Change of Indications on the Products and Packaging Boxes Due To the Removal of the EAC Mark

MELSEC series, MELIPC series, GOT series

FA-A-0396-A

5.1 Indications on those Products

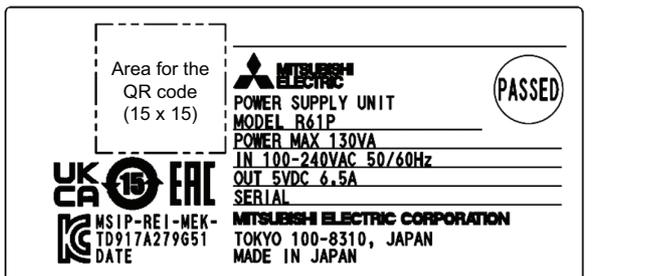
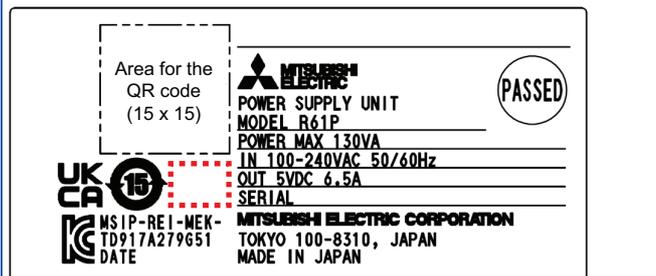
The EAC mark is removed from the relevant products and their packaging boxes.

Before change	After change
 <p>Area for the QR code (15 x 15)</p> <p>MITSUBISHI ELECTRIC POWER SUPPLY UNIT MODEL R61P POWER MAX 130VA IN 100-240VAC 50/60Hz OUT 5VDC 6.5A SERIAL</p> <p>PASSED</p> <p>UK CA 15 EAC MSIP-REI-MEK- TD917A279G51 DATE</p> <p>MITSUBISHI ELECTRIC CORPORATION TOKYO 100-8310, JAPAN MADE IN JAPAN</p>	 <p>Area for the QR code (15 x 15)</p> <p>MITSUBISHI ELECTRIC POWER SUPPLY UNIT MODEL R61P POWER MAX 130VA IN 100-240VAC 50/60Hz OUT 5VDC 6.5A SERIAL</p> <p>PASSED</p> <p>UK CA 15 EAC MSIP-REI-MEK- TD917A279G51 DATE</p> <p>MITSUBISHI ELECTRIC CORPORATION TOKYO 100-8310, JAPAN MADE IN JAPAN</p>
